METROPOLITAN AREA PLANNING
DEPARTMENT

Re: S/D 90-71 (Final Plat) Eck 4th (Killingsworth) Addition

STAFF REPORT
(Final Plat)

CASE NUMBER: S/D 90-71 - ECK 4TH ADDITION

VICINITY MAP:

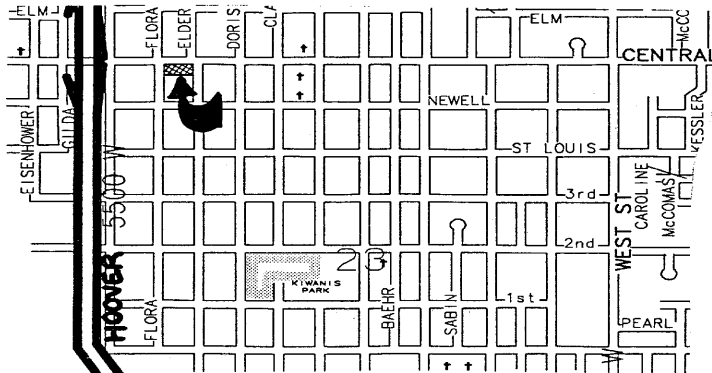
- A. The applicant shall provide for the paving of Flora adjacent to the west line of this plat.
- B. The applicant shall provide for the closure of the existing drives to Central. Complete access control is being dedicated to Central from this site.

- C. The final plat shall reference a tie point to a previously platted lot corner or section corner.
- D. In honor of a deceased Fire Fighter, the name Killingsworth has been recommended for this Addition. The final plat tracing shall therefore indicate the name "Killingsworth" for this plat. Subdivision members should mark their files and plats accordingly.

- E. The applicant shall install or guarantee the installation of all utilities and facilities which are applicable and described in Article 8 of the MAPC Subdivision Regulations.

- F. The applicant's engineer is advised that the Register of Deeds is requiring the name(s) of the notary public, who acknowledges the signatures on this plat, to be printed beneath the notary's signature.

- G. Perimeter closure computations shall be submitted with the final plat tracing. Section 5-101(c).
- H. Recording of the plat within 30 days after approval by the City Council.

- I. The representative from City Engineering should be prepared to comment on the status of the applicant's drainage plan.
